Application: D02-02-26-0012 (Minor ZBLA) and D07-  
12-26-0014 (SPC)

TREE CONSERVATION REPORT ADDENDUM 4.0

71 Russell Ave

The primary purpose of this version is to provide updated health and measurements for **Tree 10** following subsequent site inspections conducted on July 29 and August 18, 2026. Furthermore, this document addresses the comments issued by the City on August 6, 2026, regarding the July 20 submission.

Figure 1: Image of updated site plan with the surveyed location of tree 10 and proposed notch. The static root zone is shown in blue, the proposed excavation in green, and the old wooden wall in the hashed blue line

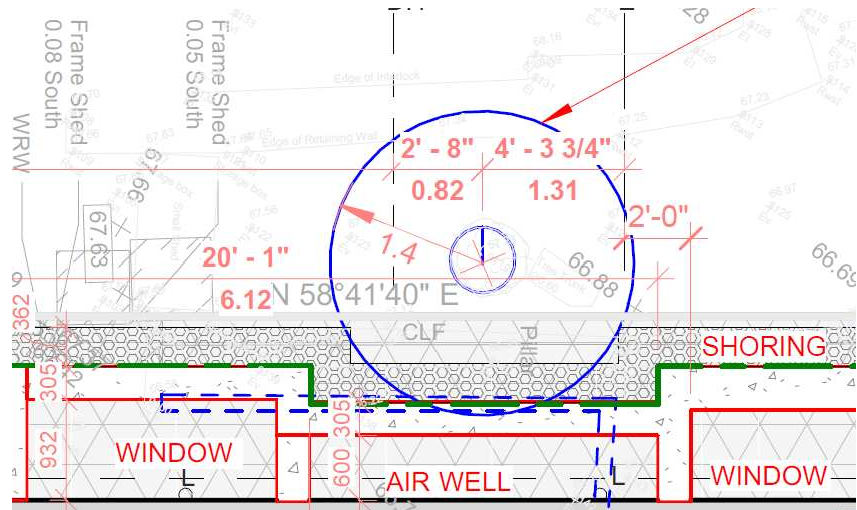
*o The static root zone of a tree is defined by the International Society of Arboriculture Best Management Practices as the tree's diameter times three. For a 45cm diameter tree, the static root zone would be 1.35m. No lateral cut to a root shall be made in this area without risking instability. The TCR states the wooden structure on site was 40cm from the L bend and 90 cm to centre of the tree. The excavation to install the shoring is stated as being 20 cm closer to the tree than the wooden wall. This does not align with the ISA BMPs that suggest no roots should be cut in a tree's static root zone. The TCR needs to outline what the static root zone for this tree is and how far excavation/root pruning would need to be from the tree to avoid compromising this trees health and stability. This must align with the civil plans.*

The project team has redesigned the wall to include a notch around the tree that relocated the shoring and proposed retaining wall to follow the path of the previous wooden wall, which followed the extent of the roots on the subject property immediately adjacent to the tree. The image below shows the updated site plan that includes the surveyed location of the tree and the location of the old wooden wall (extent of roots) as the dashed blue line. The green line represents the extent of excavation via shoring. This notching also demonstrates how the roots beyond the elbow of the old wall that will be severed as part of the shoring installation are outside of the static root zone, which is defined as three times the diameter of the tree. Although the diagram shows the measurement of the static root zone from the centre of the tree, the excavation is still outside of the static root zone if measured from the edge of the tree (an additional 23 cm).
